Proposed Large-scale Residential Development (LRD) in the townland of Boherboy, Saggart, Dublin 24.

**Statement of Response to South Dublin County Council
LRD Opinion Ref. LRDOP003/25.**

DATE: **December 2025.**

Fig. 1 – Indicative site layout plan for school site illustrating the accommodation of a 16 classroom primary school on same

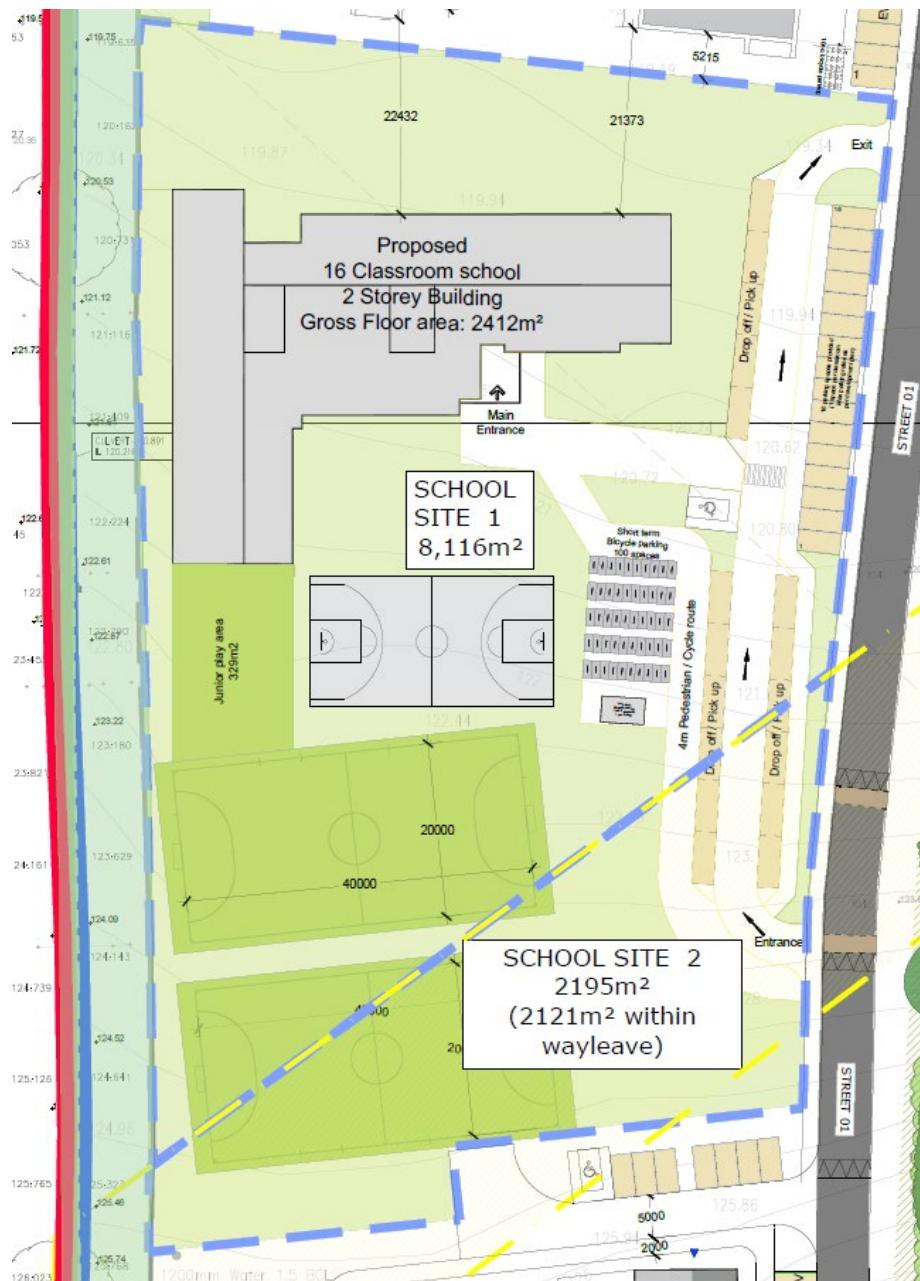
As per discussion with the Department of Education and Skills, the site, as detailed, is the preferred location for a new school.

In accordance with the Development Plan (and previous Fortunestown LAP) the Applicants have reserved a site in the north-west part of the overall Boherboy lands for future use as a school site, should the Department of Education and Skills. The Applicants engaged with the Department and submitted a final indicative design proposals to demonstrate that on the reserved site, a potential 8-16 classroom primary school can be accommodated on same. An indicative site layout plan for the school site was submitted to the Department of Education by the applicants on 27th February 2025, with a snapshot of same shown in Fig. 1 overleaf.

The footprint of the school building shown in Fig. 1 is based upon a permitted primary school. There is a wayleave traversing the southern part of the "school site", however, no buildings are proposed on the wayleave.

There are no public paths/routes through the site, and it is a self-contained site for the potential, future needs/use of the school.

The site layout plan for the school accommodates the 10m biodiversity buffer from the western boundary of the site.

Play facilities associated with the needs of the school are also accommodated within the site, as is car and bicycle parking – the numbers of same are indicative.
